[Docket No. 99–SW–81–AD; Amendment 39–11901; AD 2000–18–14]

Airworthiness Directives; Sikorsky Aircraft-Manufactured Model CH–54A Helicopters

ACTION: Final rule.

Rework of Second Stage
Lower Planetary Plate (6435-20229-102)
Figure 1

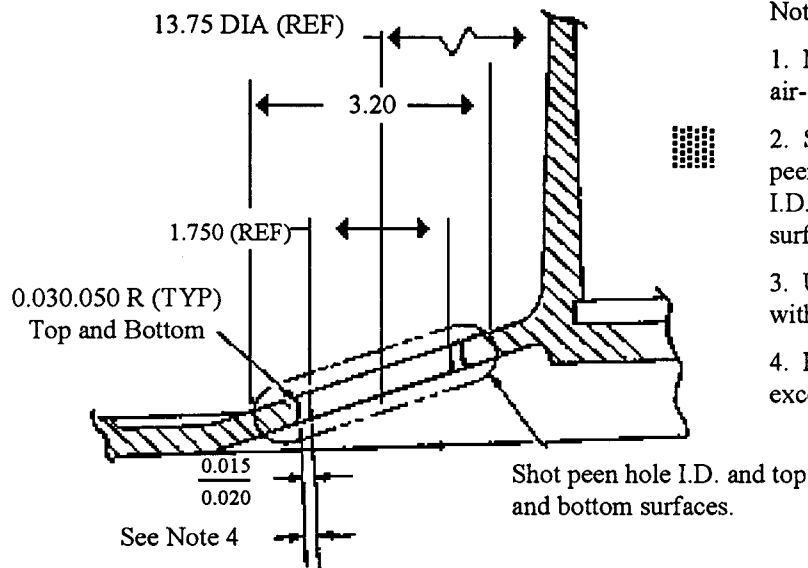
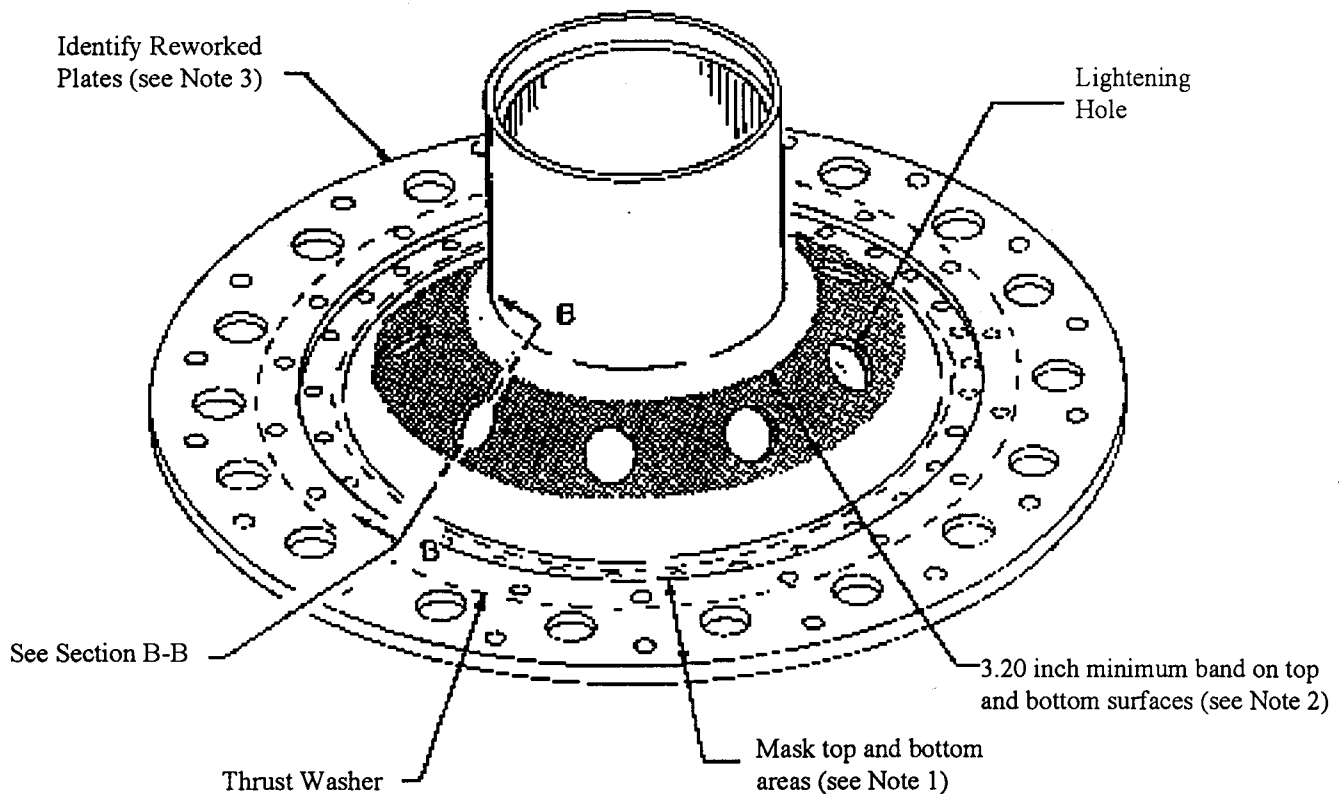
(a) On or before accumulating 1,300 hours time-in-service (TIS), conduct a fluorescent magnetic particle inspection of the plate, P/N 6435-20229-102, in the circumferential and longitudinal directions using the wet continuous method. Pay particular attention to the area around the 9 lightening holes.

(i) Locate the center of each 1.750 inch-diameter lightening hole and machine holes 0.015 to 0.020 oversize on a side (0.030 to 0.040 diameter oversize). Machined surface roughness must not exceed 63 microinches AA rating (see Figure 1).

(ii) Radius each hole 0.030 to 0.050 inches on each edge as shown in Figure 1.

(iii) Mask the top and bottom surfaces of the plate to expose 3.20 inch minimum width circumferential band as shown in Figure 1.

(viii) Identify the reworked plate by adding "TS-107" after the part number using a low-stress depth-controlled impression-stamp with a full fillet depth of not more than 0.003 inch (see Figure 1).

1. Mask top and bottom areas to protect from liquid air-grit and shot peen.
2. Shaded area to be liquid air-grit blasted and shot peened includes plate top and bottom surfaces and I.D. of all lightening holes. Feather shot peened surface edges.
3. Use low-stress depth controlled impression-stamp with full fillet depth of no more than 0.003 inch.
4. Reworked machined surface roughness shall not exceed 63 microinches AA rating.

**Borescope Inspection of
Second Stage Lower Planetary Plate
Figure 2**

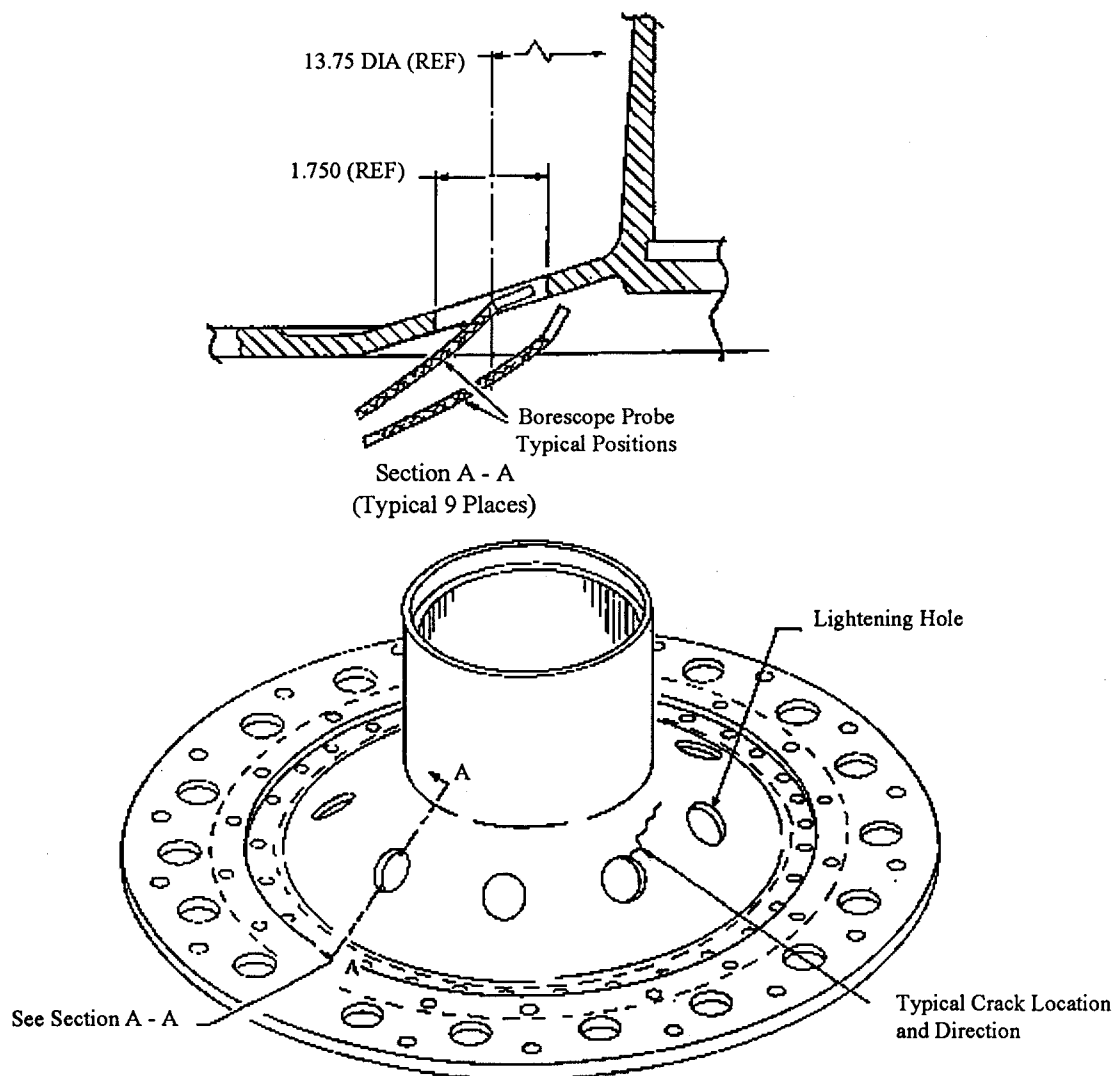
(b) For any plate, P/N 6435-20229-102, that has been reworked and identified with "TS-107," on or before the accumulation of 1,500 hours TIS and thereafter at intervals not to exceed 70 hours TIS, accomplish the following:

(1) Inspect the plate for a crack in the area around all nine lightening holes using a Borescope or equivalent inspection method (see Figure 2).

(2) If a crack is found, replace the plate with an airworthy plate prior to further flight.
